# Nessfield Primary Accessibility Action Plan April 2023

## 4.1 - ACTION TABLE

Figure 4 — Access around designated off-street parking spaces

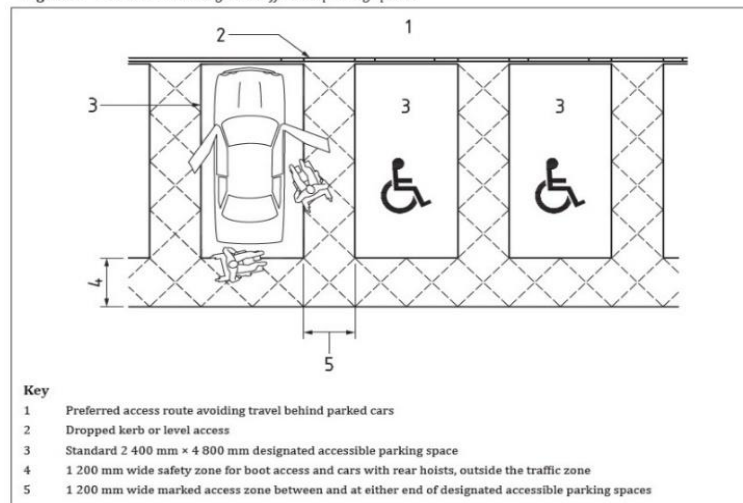
2.3	The designated accessible parking should be clearly marked out at least 2.4m wide x 4.8m long plus a 1.2m side transfer zone at the side and end of the bay.	<p>The accessible bay markings should provide clearly defined 1200mm transfer zones to both sides and rear and with the required access symbol.</p> <p>BS8300 recommends a sign or, if appropriate, signs should be provided at the entrance to each car park and at each change in direction to direct disabled motorists to designated parking spaces. Also, install a sign to the front of each space as shown:</p>	M

- 1 Preferred access route avoiding travel behind parked cars
- 2 Dropped kerb or level access
- 3 Standard 2 400 mm x 4 800 mm designated accessible parking space
- 4 1 200 mm wide safety zone for boot access and cars with rear hoists, outside the traffic zone
- 5 1 200 mm wide marked access zone between and at either end of designated accessible parking spaces

**Diagram 3 Relationship of ramp gradient to the going of a flight**

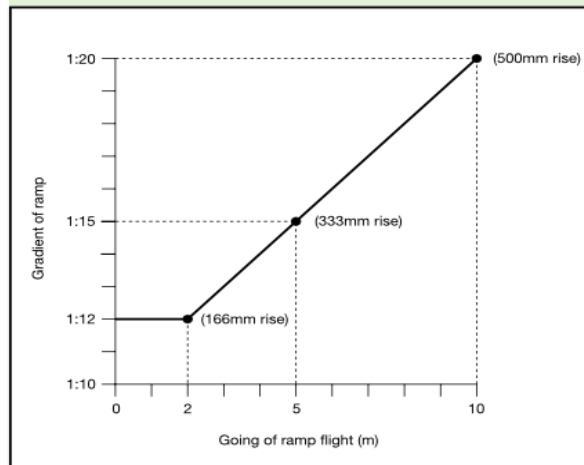
The ramps do not have colour contrast to the surface to indicate the presence of a gradient. Some ramps are steep such as those from the entrance gates (3, 4) which have a gradient of over 1:12. They also do not have handrails on both sides, or for the full incline.

Ramp from gate 3 Gradient max 10deg

ADM require ramp gradients to be within 1:20 - 1:12. Dependent on heritage requirements, surfaces need to be slip-resistant especially when wet and of a colour that contrasts visually with that of the landings.

Some of the current access route ramps are of a gradient steeper than that deemed reasonable under ADM. Where possible, during any future works, the gradients of these primary access routes should be reduced to provide an ADM compliant ramp gradient as below:

Figure 40 — Unisex accessible toilet with corner WC layout where other accessible toilet accommodation is available

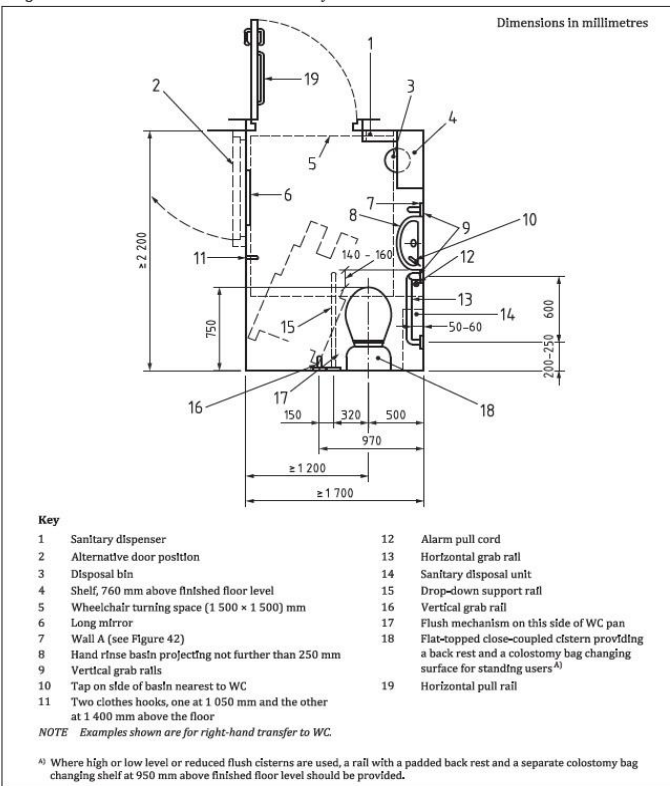
13.2	<p>Accessible WCs are only provided in two parts of the school at almost opposite ends (Block 1 and Block 3). No other accessible facility is provided.</p> <p>The Accessible WC by the main entrance would not meet current BS8300 recommendations.</p>	<p>Proportionate to demand, an architectural feasibility study should be undertaken to provide a further BS8300 compliant accessible WC facility within the lower area of the school, or refurbish the WC by the main entrance. Wheelchair Accessible WC facilities will satisfy ADM requirements if one is located as close as possible to the entrance and/or waiting area of the building.</p> <p>BS8300: A disabled employee or student should not have to travel more than 40 m on the same floor from their workstation to an accessible toilet, or more than 40 m combined horizontal travel distance where accessible toilet accommodation is accessed by conventional passenger lift on another floor of the building.</p> <p>☐</p> <p>BS8300 should be referred to for the suggested layout and guidance, with the minimum recommended layout shown below. The door should open outward, an alarm should be installed within the facility and the fittings and grab rails should be well contrasted.</p>	M/ST

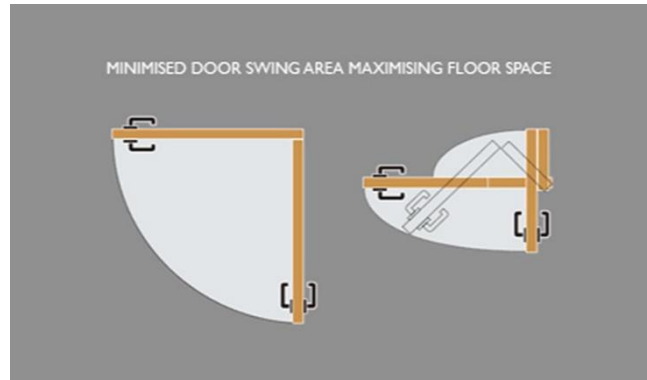
The Accessible WC with shower and hoist in room 39 has an inward opening door. It is used as first aid room. Kept locked - key locker, located high.

BS8300 recommends outward opening doors in regards to sanitary accommodation. However the use of reduced-swing doorsets, which have a sliding/folding action, reduces the door swing into the room and corridor and supports manoeuvring in and out of toilets and bathrooms.

Any door to sanitary accommodation, whether opening inwards or outwards, should be capable of being opened in an emergency if a person inside has fallen against it and is unable to move. The use of pivot hinges, in conjunction with an emergency release door stop and bathroom lock openable from the outside, can provide this facility.

If required, would be recommend to consider the option of the use of a Pivette door such as seen here:  
<http://www.leaderflushshapland.co.uk/Integrated-doorsets/Doorset-solutions/Pivette>

If an inward opening door is the only solution for a cubicle that is accessible to a wheelchair user, a clear minimum space (on plan) of 800 mm × 1 400 mm should be provided between the door swing and any fittings (including drop-down rails when in the down position) to enable a wheelchair user to enter and close the door behind them.

Figure 47 — Urinals accessible to wheelchair users and people with ambulant mobility impairments

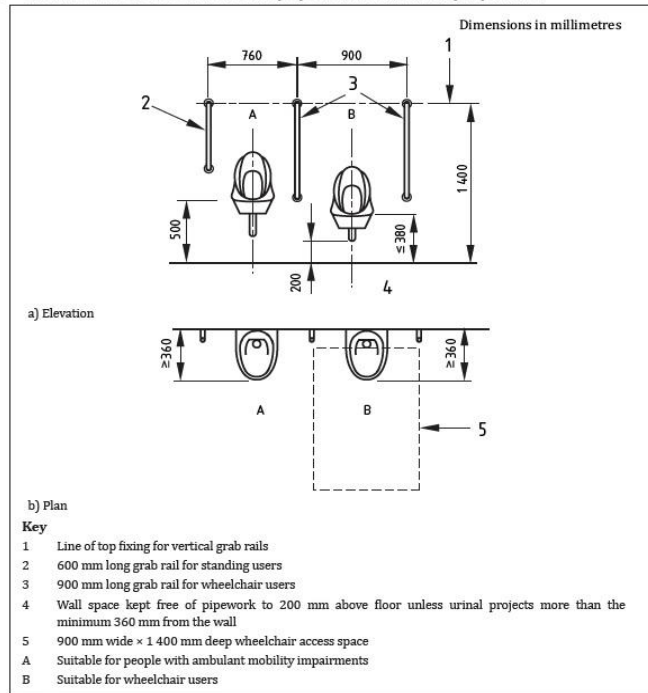
12.5	Urinals do not feature grab rails to aid ambulant disabled persons.	<p>It is suggested that urinals for wheelchair users and ambulant disabled people are provided as well. The wheelchair space in front of a urinal should be level. Vertical grab rails for the benefit of a disabled person who is standing should be provided on each side of a urinal where stall privacy dividers are not fitted.</p> <p>Fittings, support rails and grab rails should contrast visually with the wall; the WC seat and cover should contrast visually with the WC pan and cistern; and sanitary fittings and accessories should contrast visually with the background against which they are seen.</p> <p>See below for suggested layout.</p>	<b>M</b>	
------	---------------------------------------------------------------------	-------------------------------------------------------------------------------------------------------------------------------------------------------------------------------------------------------------------------------------------------------------------------------------------------------------------------------------------------------------------------------------------------------------------------------------------------------------------------------------------------------------------------------------------------------------------------------------------------------------------------------------------------------------------	----------	--

Figure 46 — Accessible WC compartment for people with ambulant mobility impairments

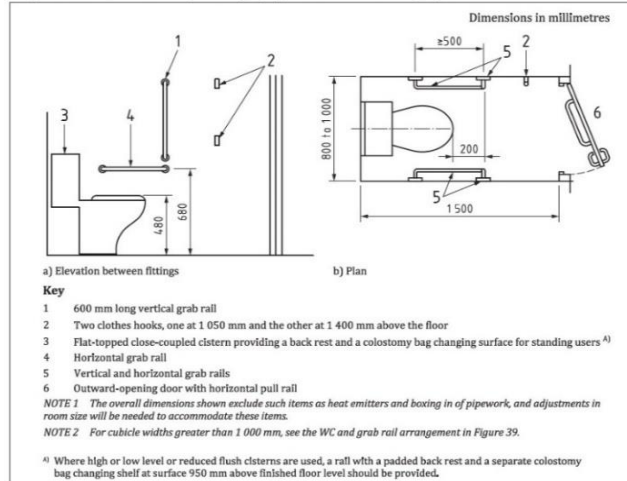
Two accessible facilities are provided but they are only in 2 parts of the school. One children's WC had a temporary frame/ grab rails but no other facility to aid ambulant disabled persons was seen.

As the toilets throughout the site are refurbished, there should be an internal standard or set of guidelines. These should state that any toilet being refurbished should be checked for the feasibility of including a cubicle or facility for ambulant disabled persons. Refer to BS8300 for current recommendations.

Where separate-sex cubicle arrangements are provided, at least one cubicle suitable for use by people with ambulant mobility impairments should be provided.

Where the compartment has an inward-opening door, it should be fitted with a double action pivot set and an emergency release mechanism operated from the outside. Inward-opening compartment doors should be used only in existing buildings where there is no alternative.

All WC cubicle doors should provide a minimum clear width of 700 mm.

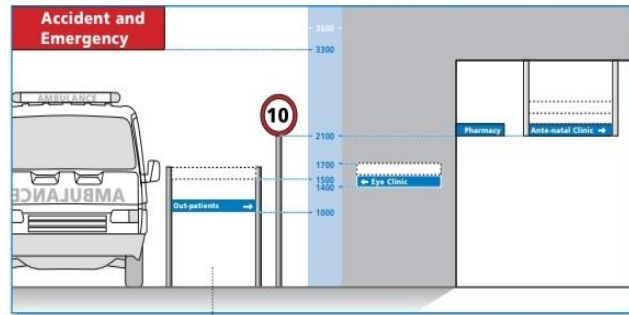
Upon entering the reception area there is a lack of suitable directory signage.

This diagram gives general guidance on the suggested height for positioning different types of sign, determined by the intended use of the sign (all dimensions are given in millimetres)

Signs and universally accepted symbols or pictograms, indicating lifting appliances, stairs, toilets, circulation routes and other parts of the building, should be provided in the reception area. The NHS Wayfinding guide and Exhibitions for All (NMS) offers good guidance regarding positioning.

Consistency of sign height and position throughout the premises is important. Signs should be placed between 1400mm and 1700mm for blind and partially sighted people when standing. For wheelchair users signs should be placed between 1000mm and 1100mm above floor level. Signs associated with control panels, e.g. lifts or door entry systems should be located between 900mm x 1200mm, to meet the needs of both wheelchair users and people standing.

The RNIB and the Joint Mobility Unit recommend positioning all signs at eye level (1500 mm), including tactile (embossed) and Braille signs. If posts are used for fixing signs, or signs are free-standing, they must contrast with the environment so they are visible for people with visual impairment.

**Diagram 21 WC cubicle for ambulant disabled people**

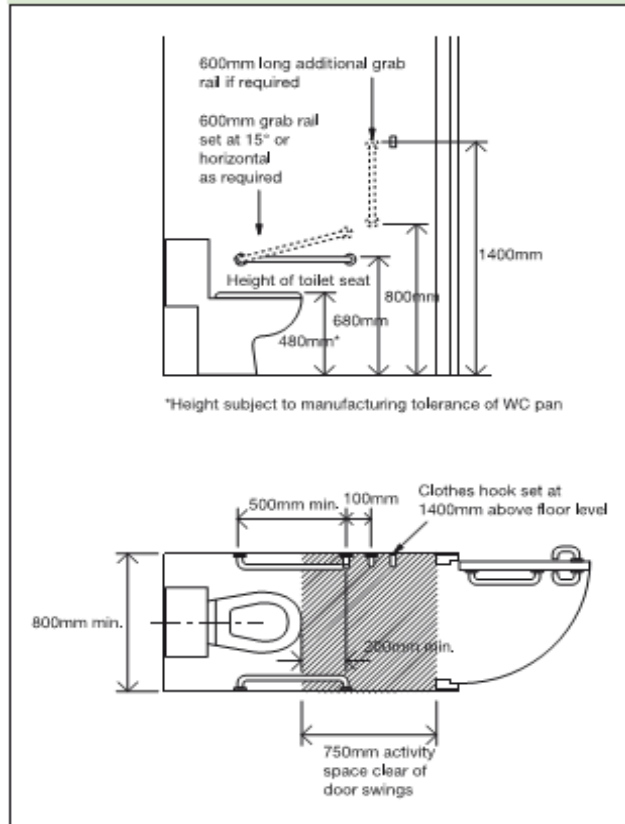
12.1	<p>Some staff WCs had limited room to manoeuvre when entering them.</p> <p>Staff WC 37 Lock located high.</p> <p>Children's WCs 19, 20 same colour cubicles</p> <p>Boys WC 6, Girls WC 8</p> <p>Staff WC 137</p> <p>Children's WC 59, 55</p> <p>Staff WC area 61</p> <p>Children's WCs 68, 69 lever taps</p>	<p>While an accessible WC is provided there are no facilities for ambulant disabled persons. It would be recommended to provide general WCs with space within it to be manoeuvrable, or used as an WC for ambulant disabled people. The door can be changed to an outward opening door, a slide door or a pivot door to increase internal manoeuvring space.</p> <p>ADM recommends the following for a cubicle, and refer to BS8300 for layout of a unisex toilet - also see recommendation 12.7.</p> <p>The swing of any inward opening doors to standard WC compartments should allow a 450mm diameter manoeuvring space between the swing of the door, the WC pan and the side wall of the compartment;</p> <p>The minimum dimensions of compartments for ambulant disabled people, including the activity space, and the arrangement of grab bars and other fittings within the compartment are as follows.</p>	M/ST

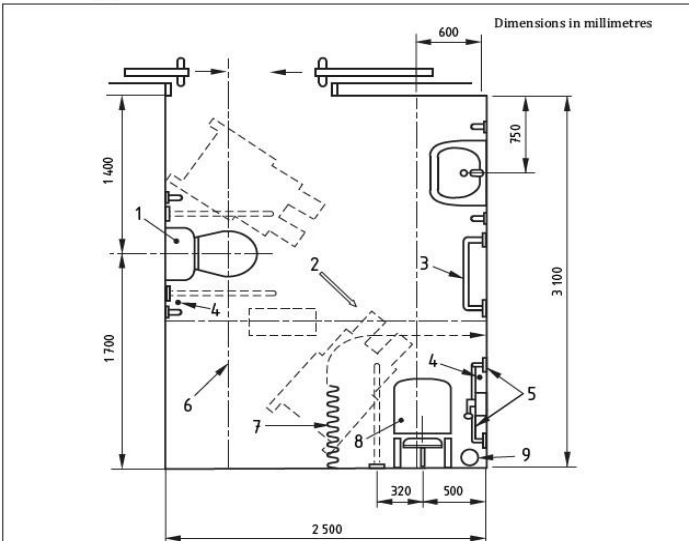
12.8	<p>An accessible shower is provided it this is not in regular use. This does not have grab rails but a seat is provided.</p> <p>A hoist is provided but this is now obstructed by the frame for the shower door and curtains.</p>	<p>As the hoist cannot be used currently, and modifications to the shower will be needed to allow this to be used, consideration should be given to refurbishing the room to provide an accessible shower room with a fully accessible WC (as recommended in 13.1) along with a suitable hoist and changing mat for assisted changing and a level access shower such as recommended in BS8300 and shown below (refer to BS8300 for other layout options):</p>	M/ST	
------	-----------------------------------------------------------------------------------------------------------------------------------------------------------------------------------------------------------------------------------	---------------------------------------------------------------------------------------------------------------------------------------------------------------------------------------------------------------------------------------------------------------------------------------------------------------------------------------------------------------------------------------------------------------------------------------------------------------	------	--
